Updated TDD PHY Control State Diagram

November 10, 2025

Introduction

Figure 149-32—PHY Control state diagram

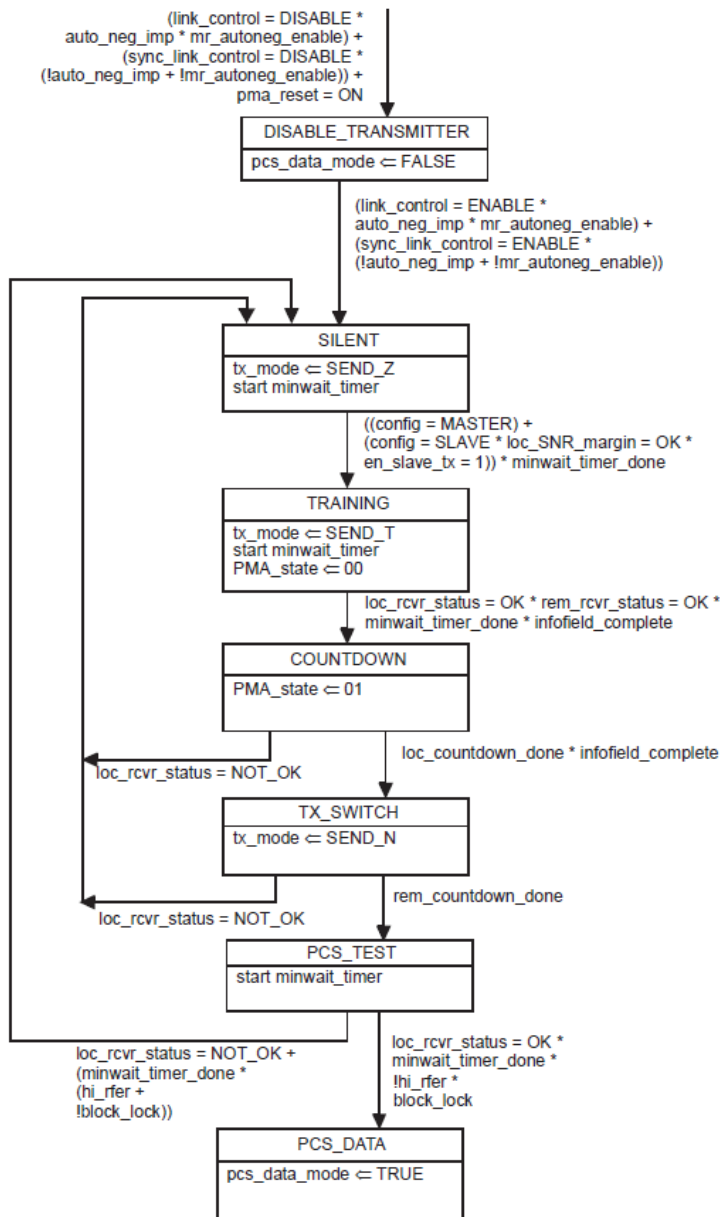
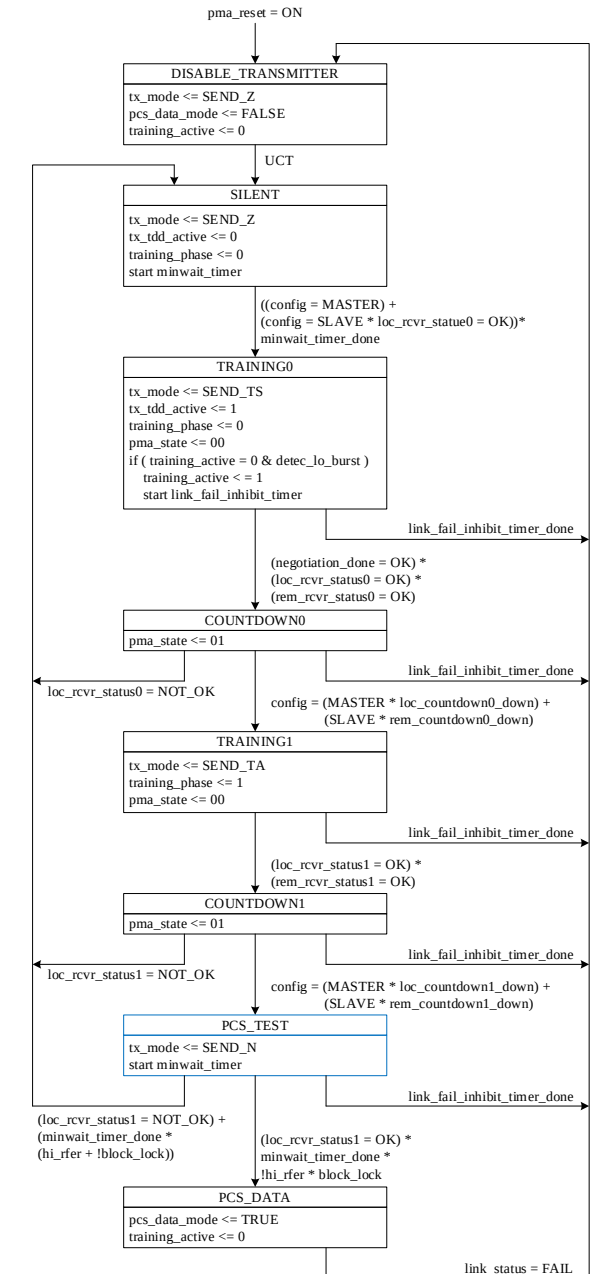
- This presentation provides update to the TDD PHY Control state diagram presented in May 2025.
 - Previous presentation: https://ieee802.org/3/dm/public/0525/Baseline_Text_TDD_051125.pdf
- The updated TDD PHY Control state diagram has the following modifications
 - SILENT1, TRAINING2, and COUNTDOWN2 are removed
 - PCS_TEST is inserted between COUNTDOWN1 and PCS_DATA

- The left figure is PHY control state diagram for 802.3ch, and the 7 states from top to bottom are: DISABLE_TRANSMITTER, SILENT, TRAINING, COUNTDOWN, TX_SWITCH, PCS_TEST, and PCS_DATA.

- The right figure is updated TDD PHY control state diagram, and the 8 states from top to bottom are: DISABLE_TRANSMITTER, SILENT, TRAINING0, COUNTDOWN0, TRAINING1, COUNTDOWN1, PCS_TEST, and PCS_DATA.
